**JUPITER INLET COLONY
BUILDING AND ZONING COMMITTEE MEETING
06.18.20**

Attn.: Plan Review 65 COLONY

RE: Response to Meeting Comments Received 05.21.20, Town Engineer Comments 06.04.20

Re: *Jupiter Inlet Colony*
 65 Colony Road
 Lot Drainage Plan Review

PROPOSED RESIDENCE GRADING & DRAINAGE PLAN
65 COLONY ROAD
JUPITER INLET COLONY, FLORIDA

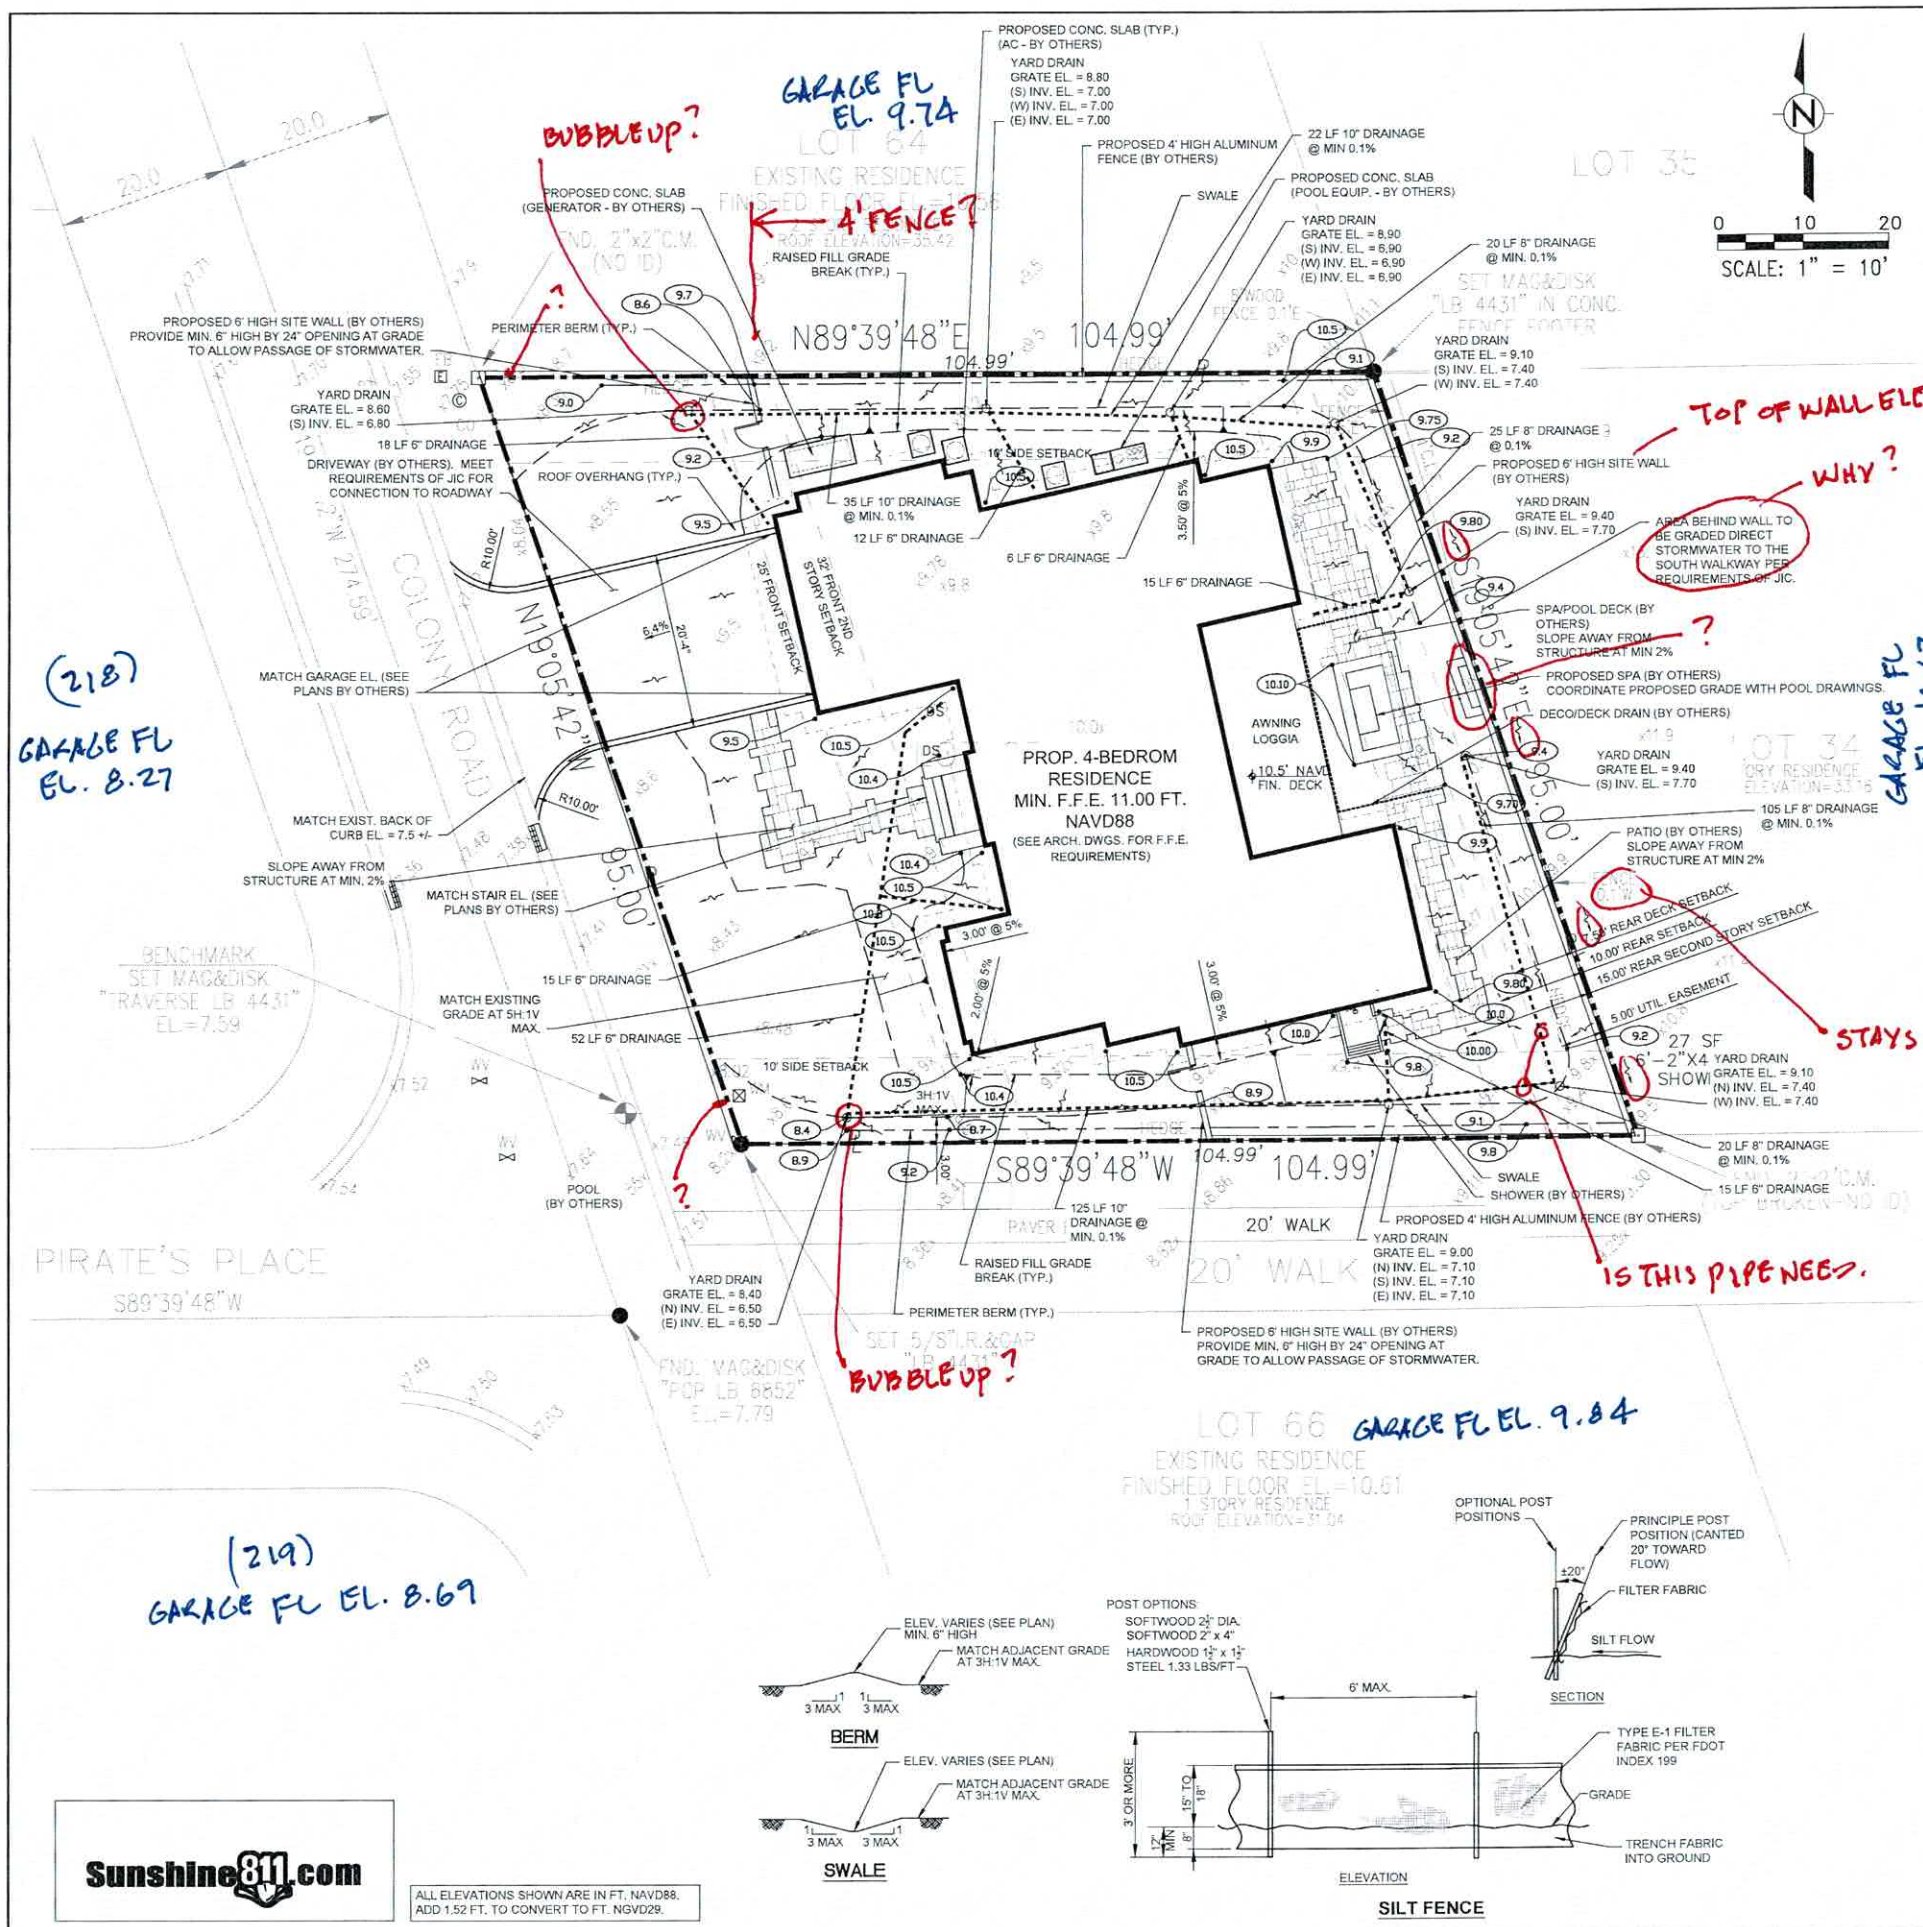
- Note that the adjacent centerline road grade in front of 65 Colony is EL 7.48. Applying the 18-inches above this grade, gives us a minimum finished floor elevation of 8.98. The plans denote a finish floor elevation of 11.0

- The plans show finished floors for 64 and 66 Colony as EL 10.56 and 10.61 respectively, for an average finished floor elevation of 10.58. Note that the home behind them, at 34 Ocean does not show a finished floor elevation.

- Based upon the above information, it would seem like the finished floor elevation for this location would be EL 10.60.
- On-site drainage pipe. (1). They need to confirm the functionality of the system, is the intent to have the two-yard drains in the front of the property to "bubble up" into the swale once the system surcharges. (2). The piping in the northeast corner, is that section of piping even needed, since the drainage can be handled via the swale.

- The proposed wall along the rear property line, is this concrete, and we should include top of wall elevations.
- The plans note that this project is to re-grade the rear property of 34 Ocean, to be graded north to south, draining into the Colony's Public walkway. Not sure we can accomplish that with the existing improvements at 34 Ocean. It may be best to just keep the grades as is, and just let it naturally flow as it does today.

- Miscellaneous items. (1). The proposed 4ft fence along the north property line, does not show its limits. (2). There are some single lines shown outside the property line, what are these lines. (3). 34 Ocean has an exiting fence in the rear of their property, is that staying in place. (4). The proposed wall and fence need to be offset to allow room for footers, the actual location is not shown. (5). A structure is shown in the rear of the property but is not called out.

Revised floor elevation, finish floor elevation 10.6' N.A.V.D.

Northeast piping for additional drainage capacity from back to front.

Added general note top of new concrete site walls and adjacent grade

Notes indicating re-grading are removed. Stormwater will build up at wall face then run south.

The note is clarified on the 4'h. fence. Random outside lines removed.

There are not plans to remove neighbors fence outside of our property line.
